SANFORD SEACOAST REGIONAL AIRPORT SANFORD, MAINE

AIRPORT MASTER PLAN UPDATE

RE: (See attached Table 1 for referenced case(s))
ALP 7460 No Objection Letter
FINAL DETERMINATION

Description: ALP Update

Title
AIRPORT DATA SHEET

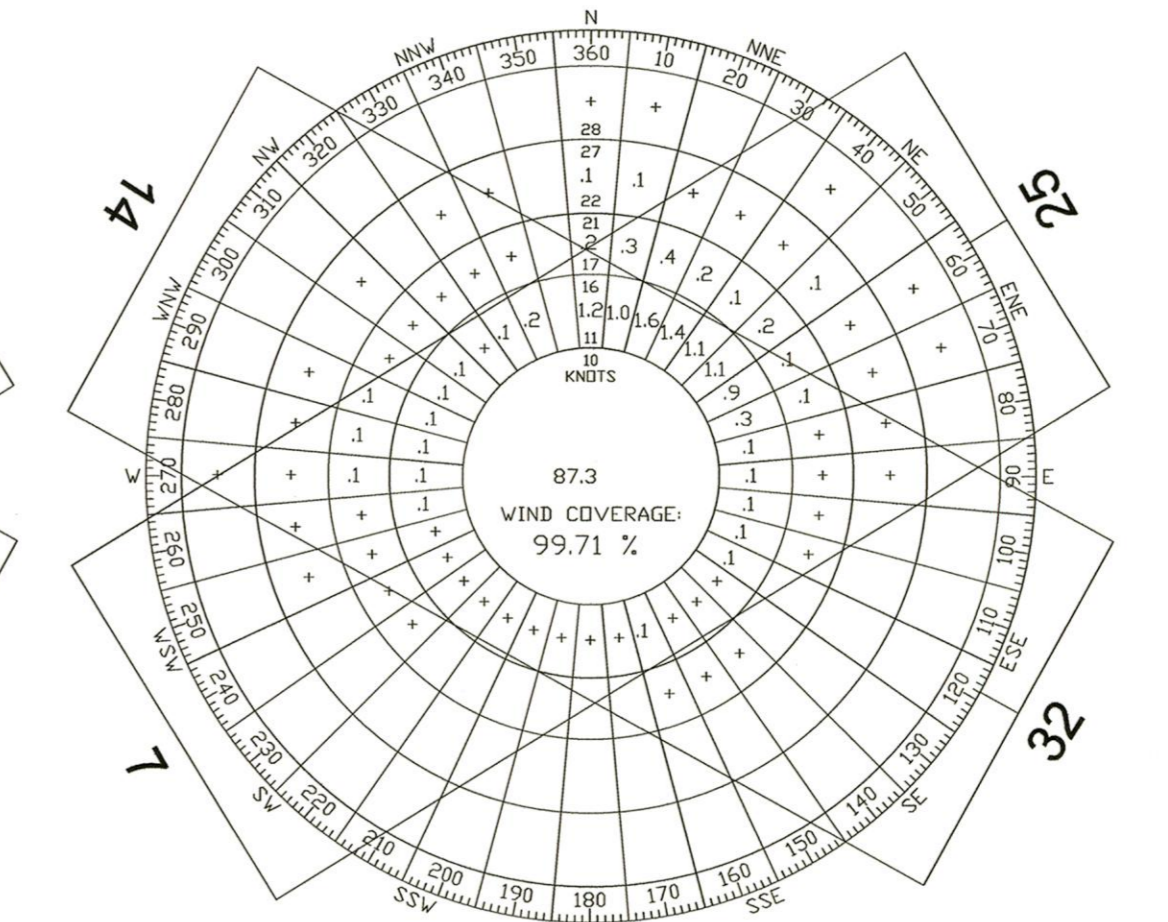
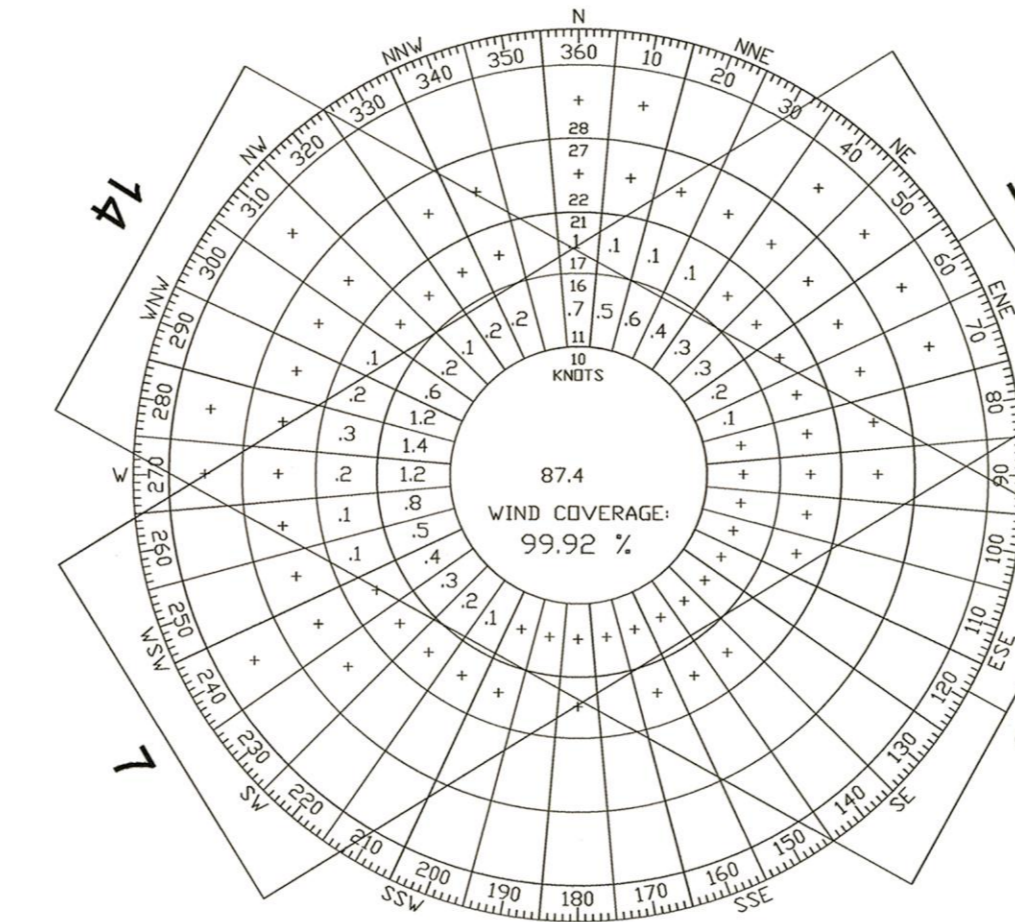
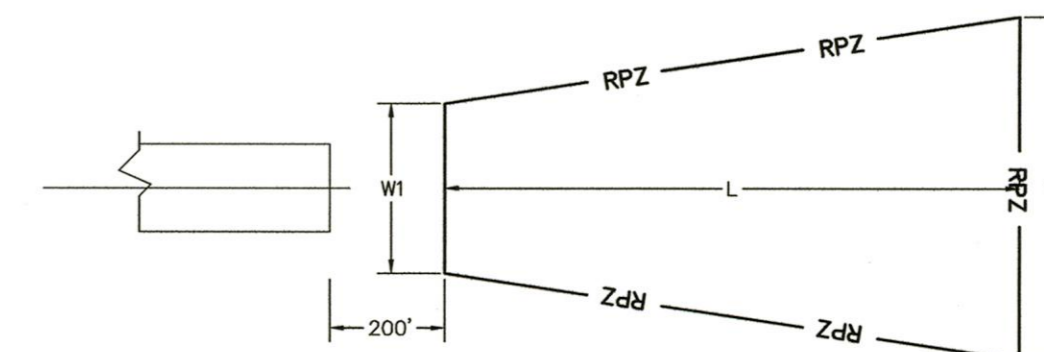
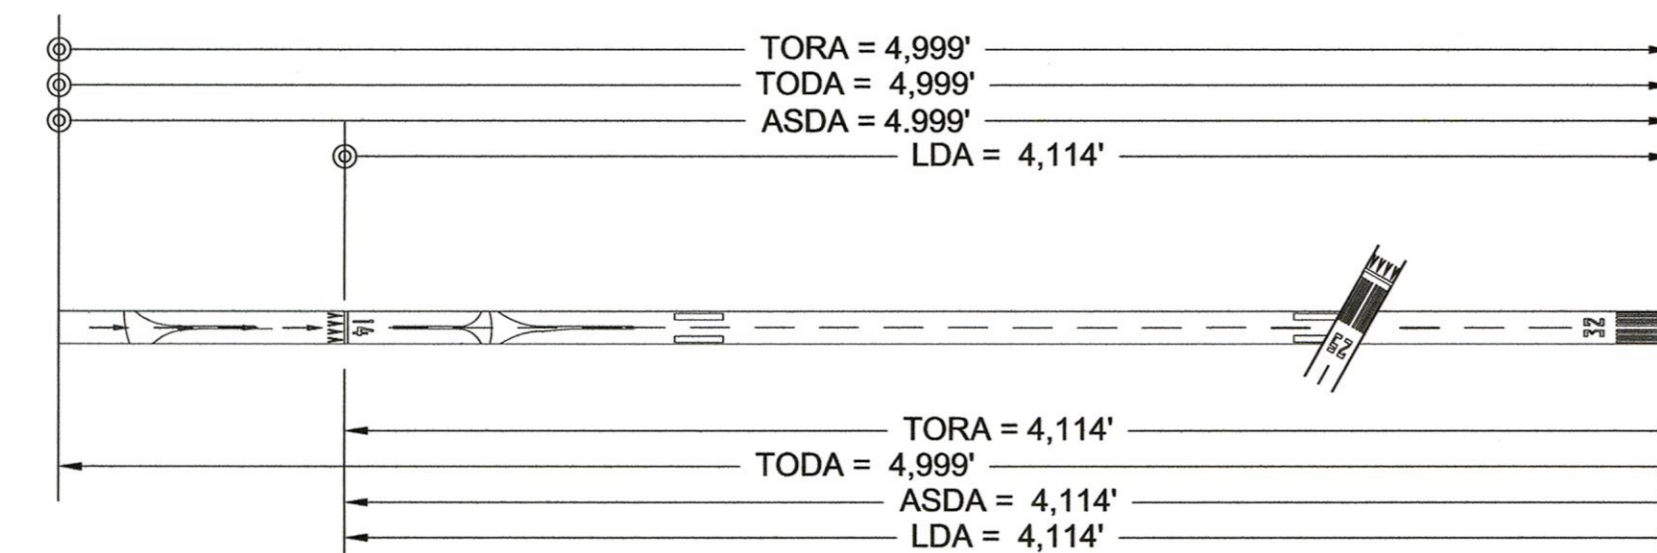
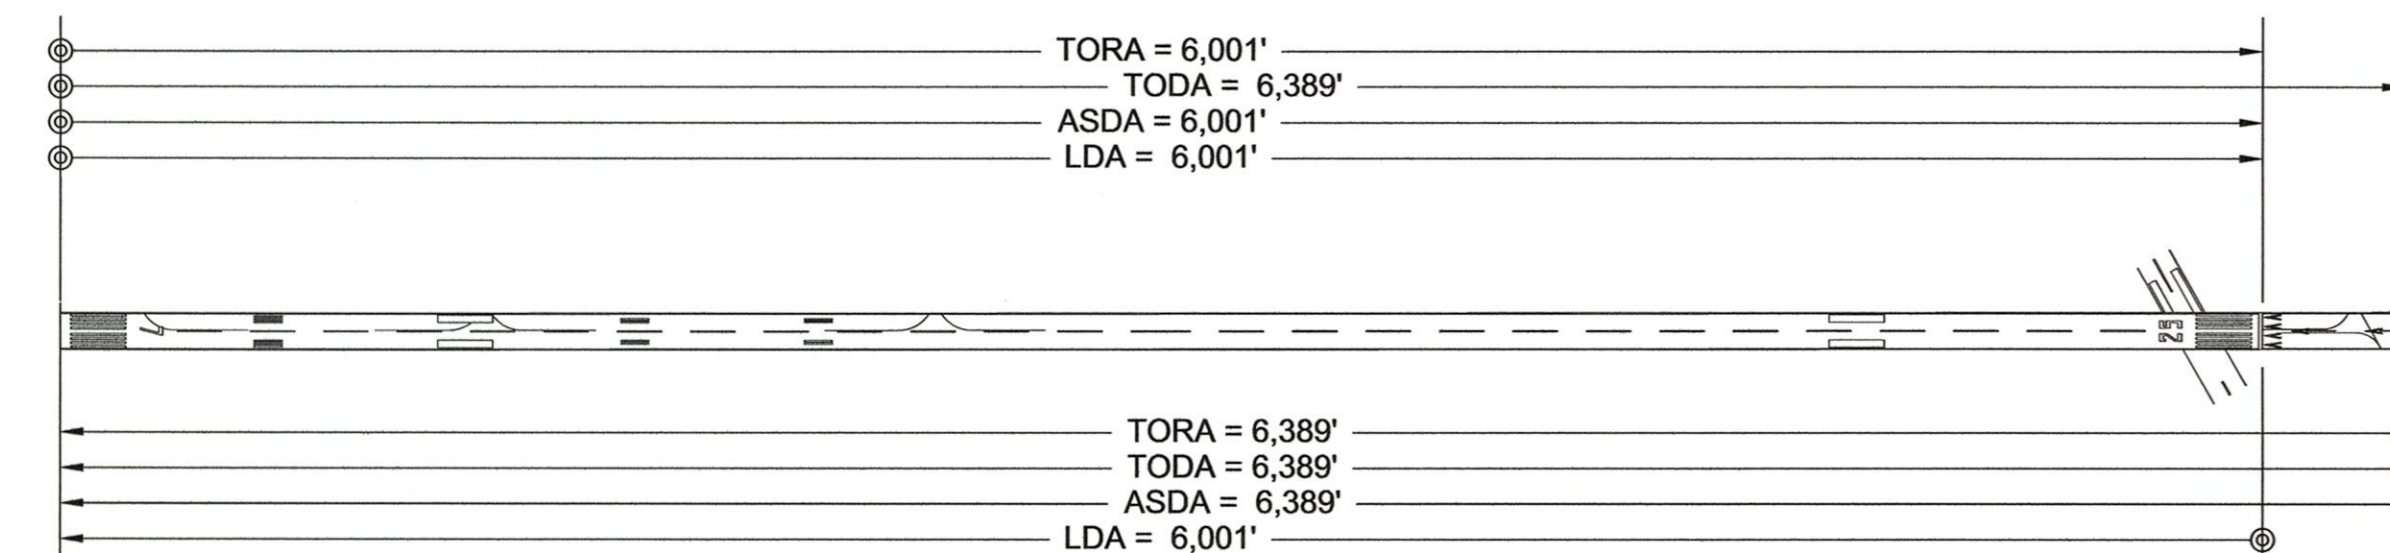
VISAIDS: Missing Runway Data Table: Provide full Runway Data Table with appropriate listing of existing and proposed runways along with their respective VISAIDS, physical dimensions, lat/long coordinates & elevations for the runway ends and displaced thresholds.
